## DEVELOPMENT APPLICATION ASSESSMENT REPORT

<b>Application Number:</b>	DA2025/0394
<b>Responsible Officer:</b>	Ryan Fehon
<b>Land to be developed (Address):</b>	Lot B DP 367133, 2 Orara Road ALLAMBIE HEIGHTS NSW 2100
<b>Proposed Development:</b>	Alterations and additions to a dwelling house
<b>Zoning:</b>	Warringah LEP2011 - Land zoned R2 Low Density Residential
<b>Development Permissible:</b>	Yes
<b>Existing Use Rights:</b>	No
<b>Consent Authority:</b>	Northern Beaches Council
<b>Land and Environment Court Action:</b>	No
<b>Applicant:</b>	Nigel White
<b>Application Lodged:</b>	01/05/2025
<b>Integrated Development:</b>	No
<b>Designated Development:</b>	No
<b>State Reporting Category:</b>	Residential - Alterations and additions
<b>Notified:</b>	08/05/2025 to 22/05/2025
<b>Advertised:</b>	Not Advertised
<b>Submissions Received:</b>	2
<b>Clause 4.6 Variation:</b>	4.3 Height of buildings: 8.235%
<b>Recommendation:</b>	Approval
<b>Estimated Cost of Works:</b>	\$ 516,811.00

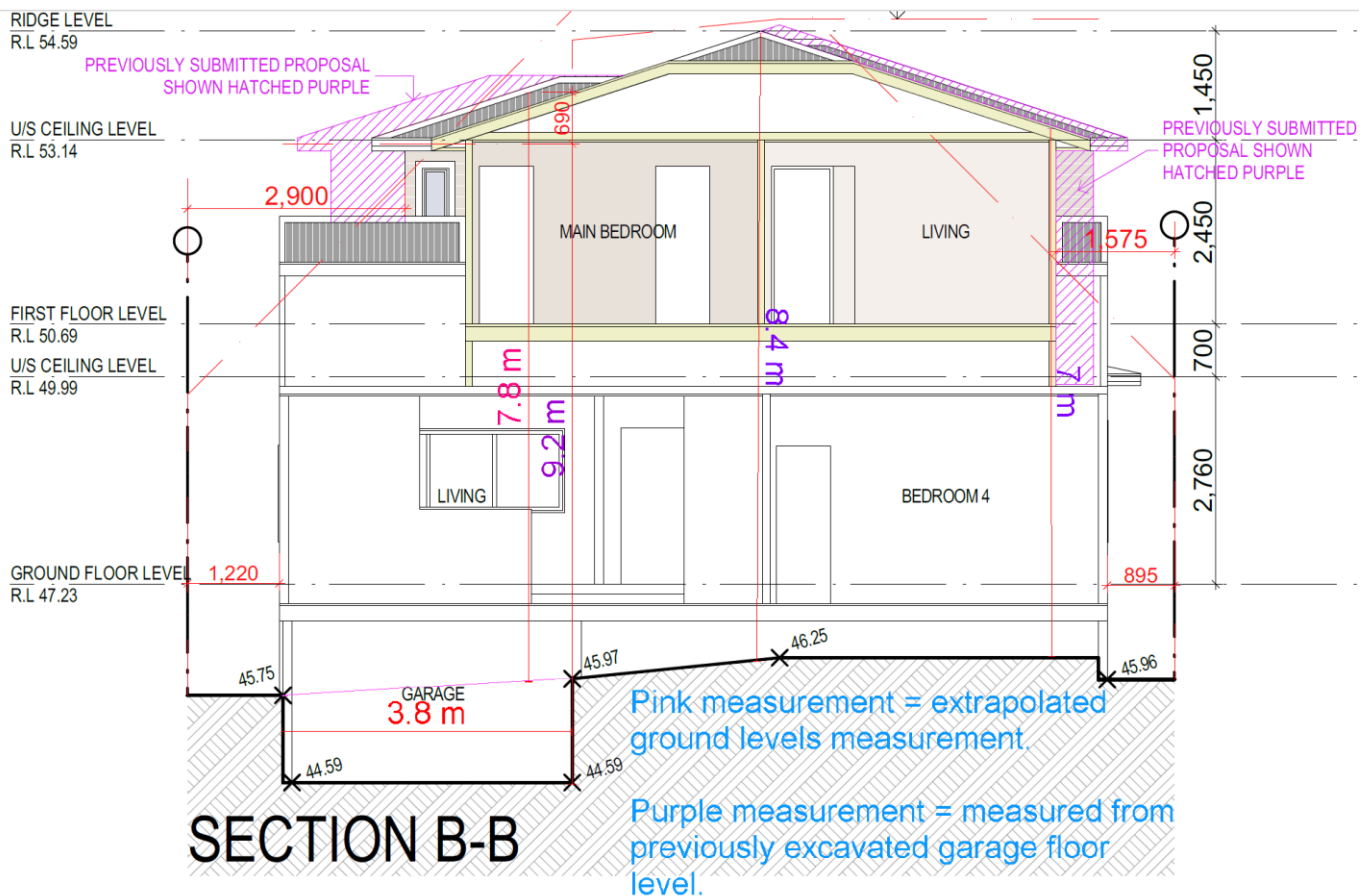
This stance from the applicant is considered satisfactory after an in-depth assessment by Council. The noncompliance of 8.235% is considered to be directly as a result of the historical excavation of the existing garage. The extent of this non-compliance is minimal, as it covers only the extent of the 3.8m wide existing garage. When measured from extrapolated ground levels, the height of the building would be fully compliant with the development standard. It is noted that the impact of this non-compliance is minimal due to appearing as a compliant two-storey dwelling when viewed from the street, not posing any impacts on neighbouring properties as a direct result of the non-compliance.

The 9.2m maximum height measurement would measure as 7.8m when undertaken on extrapolated ground levels as per the diagram below.

In this regard, the applicant's written request has demonstrated that the proposed development is an orderly and economic use and development of the land, and that the structure is of a good design that will reasonably protect and improve the amenity of the surrounding built environment, therefore satisfying cls 1.3 (c) and (g) of the EPA Act.

### **B3 Side Boundary Envelope**

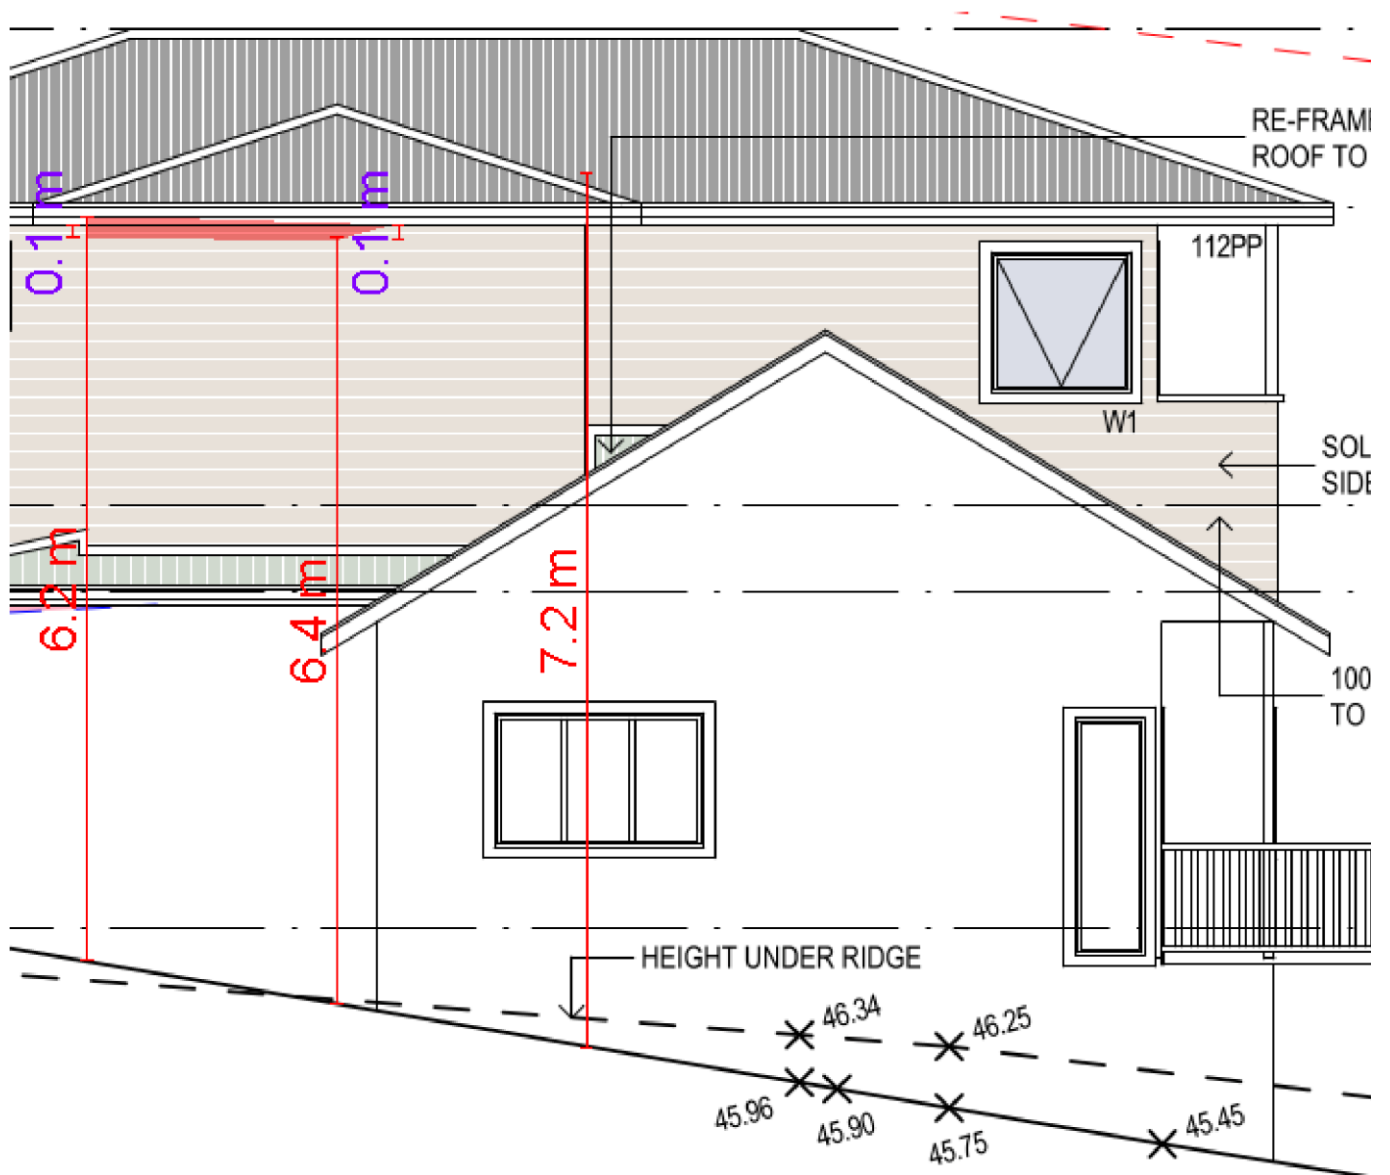
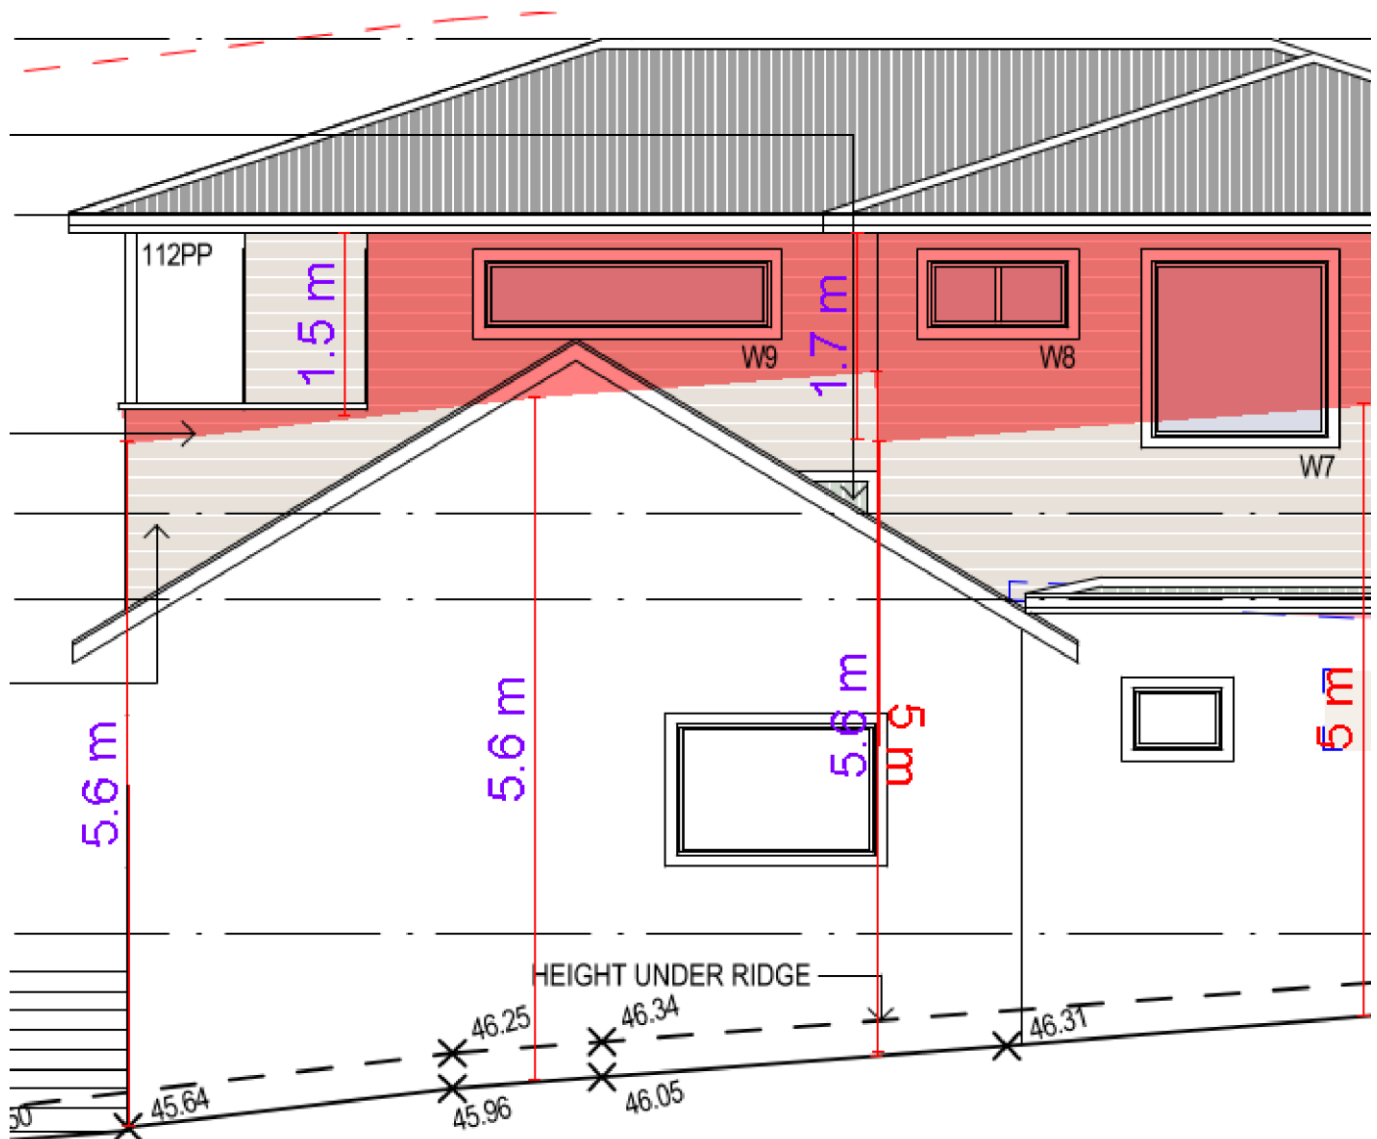
There are proposed non-compliances to the B3 Side Boundary Envelope control of the *Warringah Development Control Plan*. There is a proposed non-compliance at an extent of 0.1m (2.5%) to the southern boundary, and a maximum of 1.7m (42.5%) on the northern boundary. The original proposal was considered unacceptable, however amended plans received have been able to reduce the noncompliances on the south by between 1m-1.8m and on the north by 500mm.

The development maintains a good response to the topography of the site, with it being compliant in height for the majority of the development. The height non-compliance occurs outside of the envelope non-compliance. It is considered that due to the development being compliant with height, setbacks and wall height on the side boundaries, that the response to the topography of the site is satisfactory. Non-compliance is considered to be directly as a result of a constrained site.
